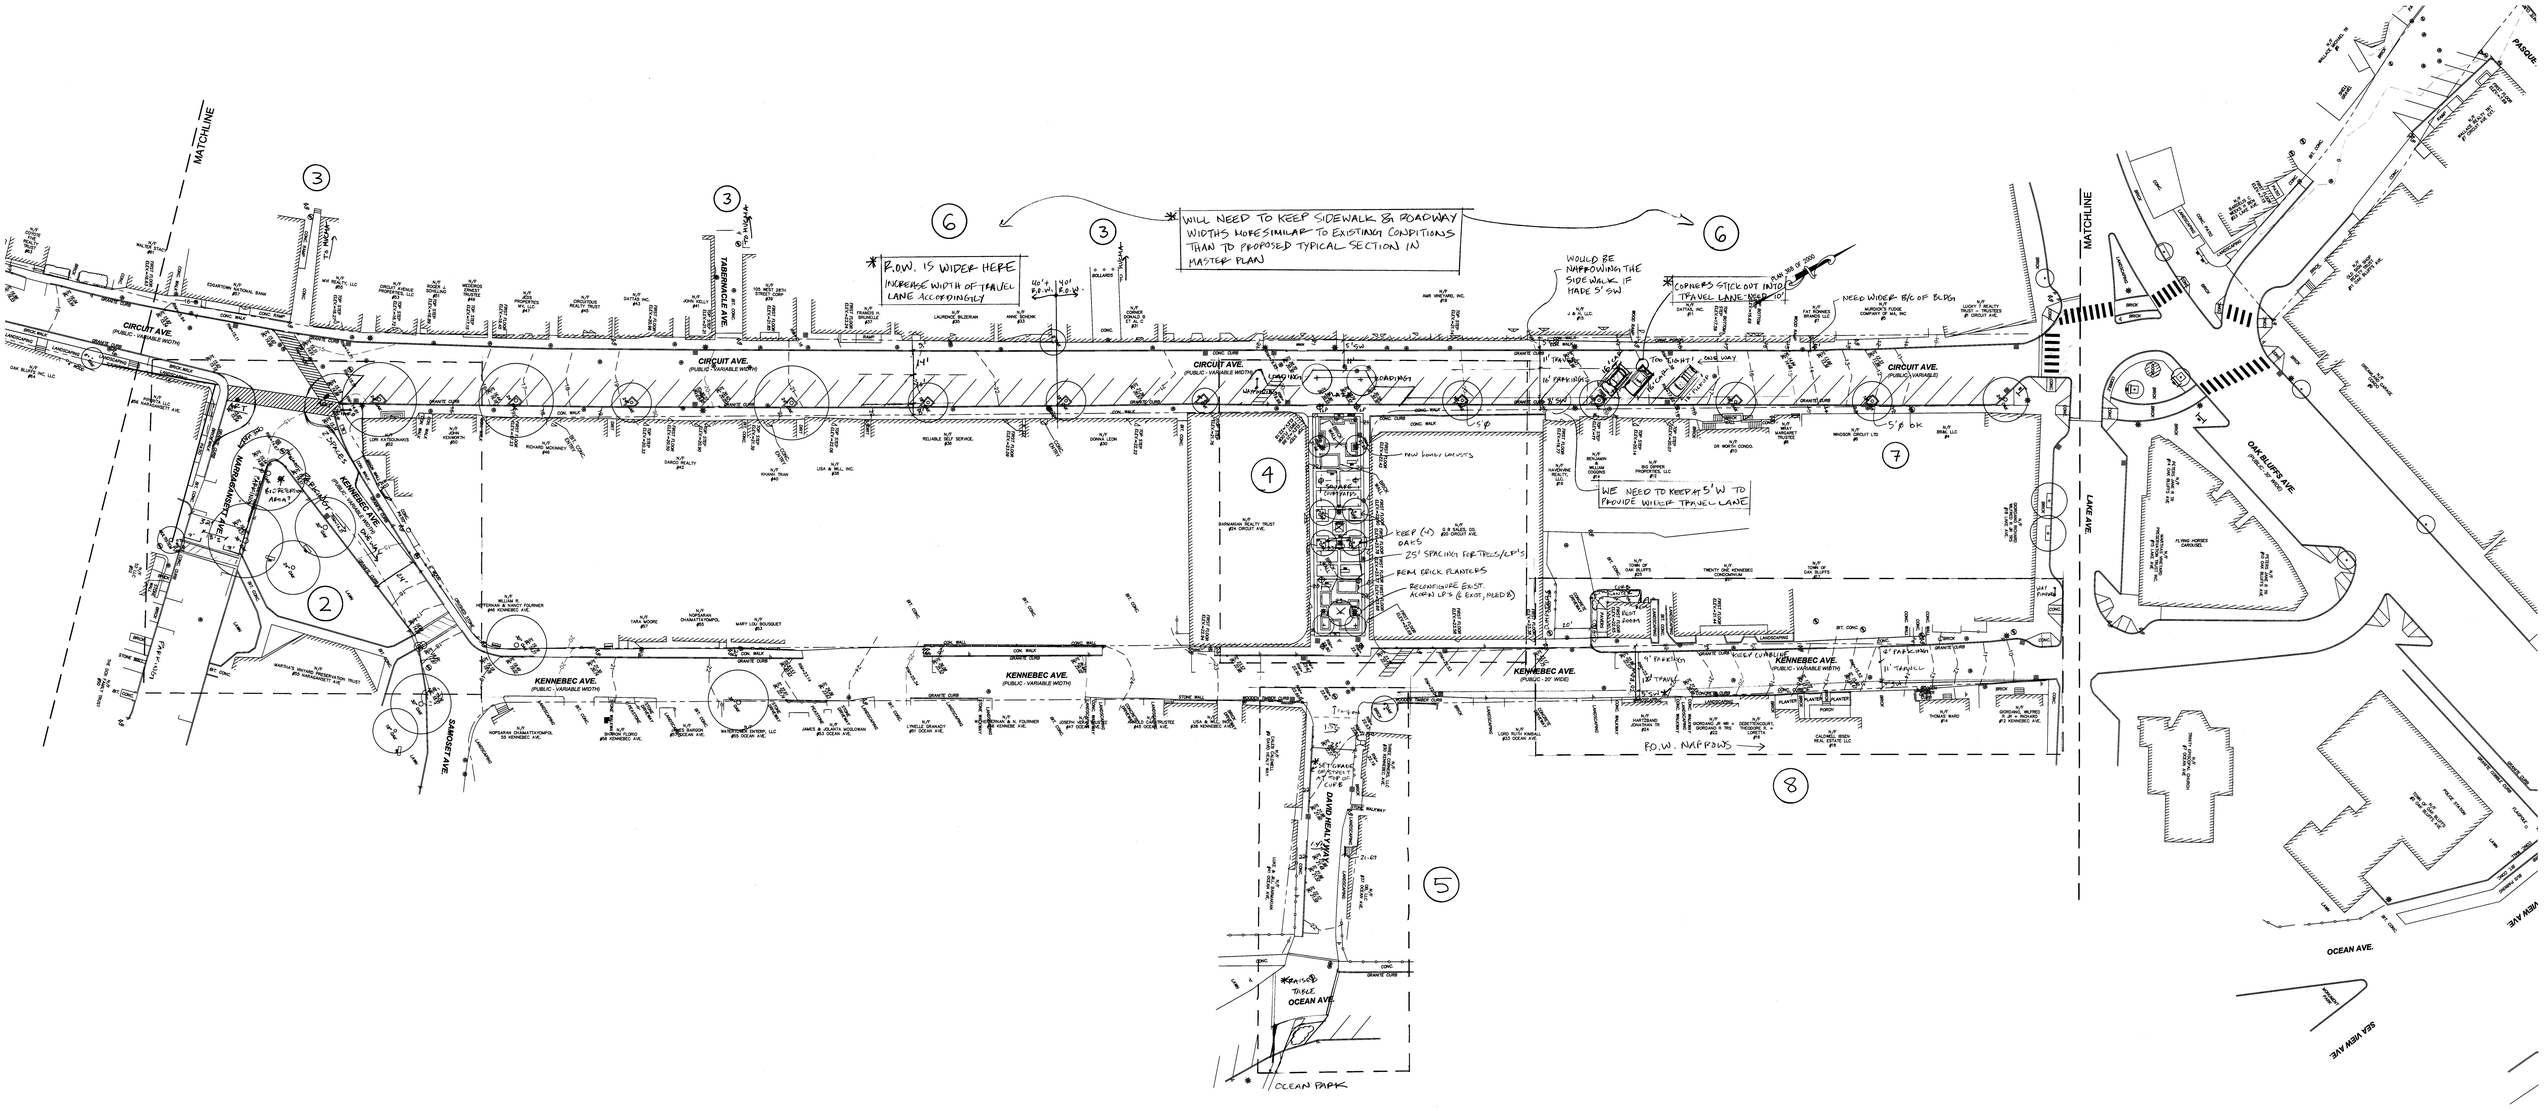
1
MATCHLINE
EVALUATE LOCATIONS FOR NEW TREES ON PRIVATE PROP.
BUILDINGS CLOSE TO SIDEWALK - NO NEW TREES
NEW SIDEWALK
NEW CURB
2-WAY
NEW X-WALK
NEW X-WALK HERE? (NOT IN MASTER PLAN)
2 SPACES
3 SPACES
* NO NEW STREET TREES - EXIST. TREES ON PRIVATE PROPERTY
ONE WAY
PARKING
CONSTRUCTION IN PROGRESS
CIRCUIT AVE.
(PUBLIC - VARIABLE WIDTH)
CIRCUIT AVE.
(PUBLIC - 30' WIDE)
GRANT CT.
HIAWATHA AVE.
UNCAS AVE.
BRADLEY AVE.
WAMSUTTA AVE.
TUCKERNUCK AVE.
PENNACOOCK AVE.
BAYLISS AVE.
MASSASOIT AVE.
PEQUOT AVE.
NARRAGANSETT AVE.
KENNEBEC AVE.
SAMOSET AVE.
TABERNACLE AVE.
N/F SCOTT F. KERRY #89
N/F PRIMO LOMBARDI #73
N/F ZITA COUSENS #71
N/F SOUTH END REALTY TRUST #69
N/F THERESE HALL TRUSTEE #67
N/F TOWN OF OAK BLUFFS #82
N/F LEONARDO FRANCIS RICHARD #83
N/F MARVIN JONES #34 MASSASOIT AVE.
N/F TOWN OF OAK BLUFFS
NIANTIC PARK
0 20 50 100 FEET
1" = 20'

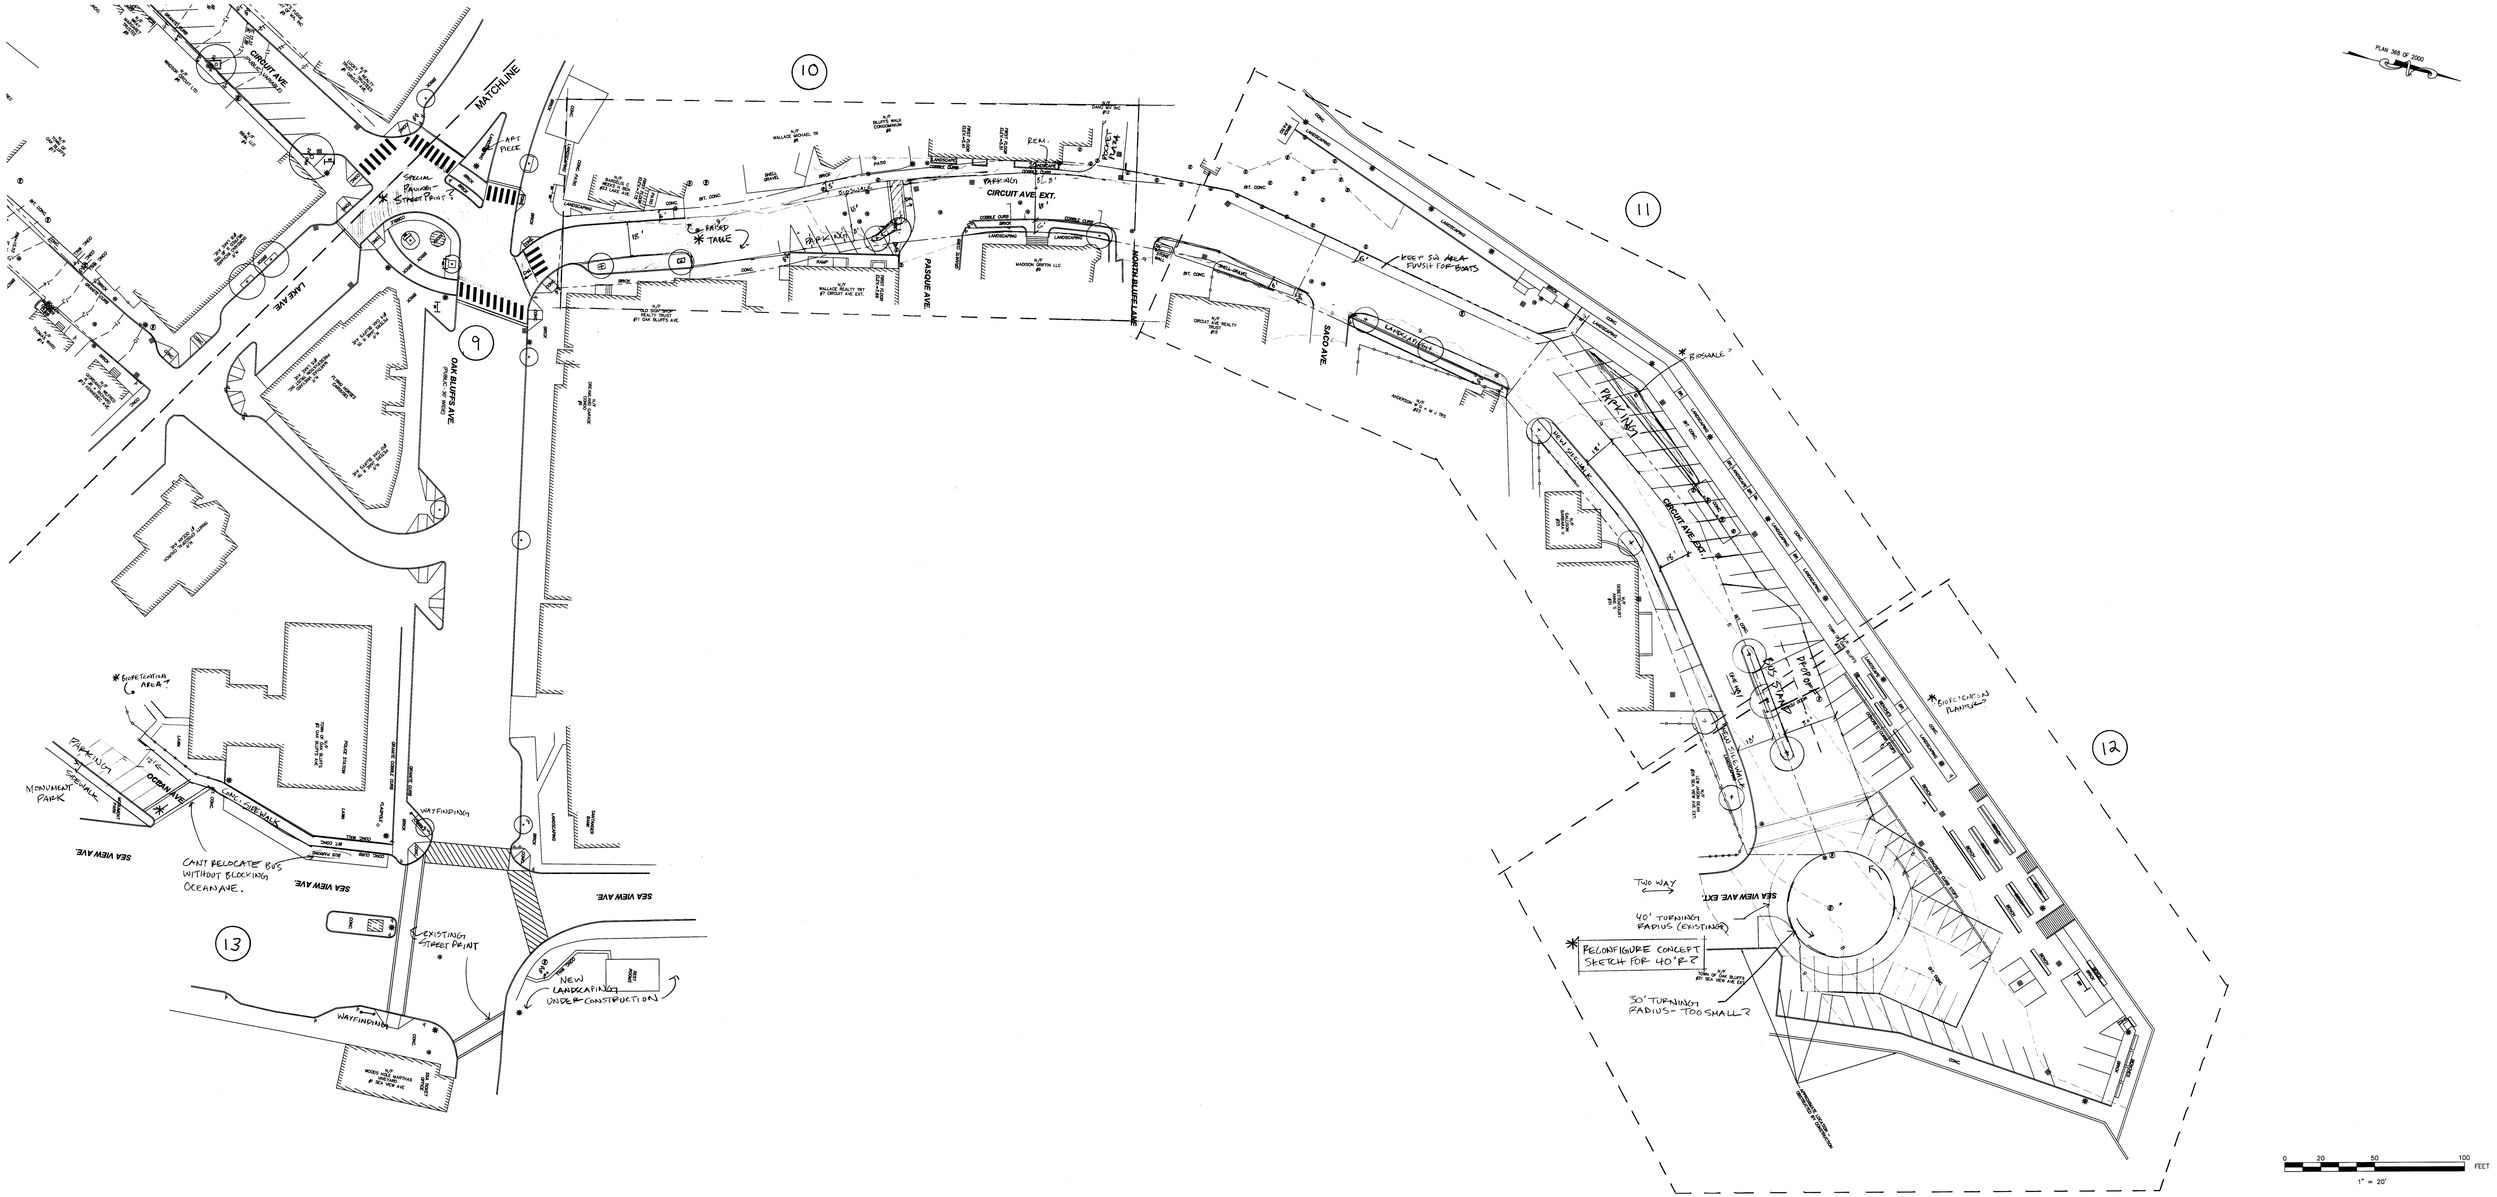
MATCHLINE
CIRCUIT AVE.
(PUBLIC - VARIABLE WIDTH)
TABERNACLE AVE.
KENNEBEC AVE.
(PUBLIC - VARIABLE WIDTH)
KENNEBEC AVE.
(PUBLIC - 20' WIDE)
SAMOSET AVE.
HARRAGANSETT AVE.
LAKE AVE.
OAK BLUFFS AVE.
OCEAN AVE.
SEA VIEW AVE.
PASQUE
DAVID HEALY WAY
OCEAN PARK
* R.O.W. IS WIDER HERE
INCREASE WIDTH OF TRAVEL LANE ACCORDINGLY
* WILL NEED TO KEEP SIDEWALK & ROADWAY WIDTHS MORE SIMILAR TO EXISTING CONDITIONS THAN TO PROPOSED TYPICAL SECTION IN MASTER PLAN
WOULD BE NARROWING THE SIDEWALK IF MADE 5' SW
* CORNERS STICK OUT INTO TRAVEL LANE - NEED TO
NEED WIDER B/C OF BLDG
WE NEED TO KEEP AT 5' W TO PROVIDE WIDER TRAVEL LANE
KEEP (+) OAKS
25' SPACING FOR TREES/LP'S
REM BRICK PLANTERS
RECONFIGURE EXIST. ACORN LP'S (& EXIST, NEED B)
R.O.W. NARROWS
* RAISED TABLE
* SET GRADE CONTINUOUS AT TOP OF CURB
0 20 50 100 FEET
1" = 20'
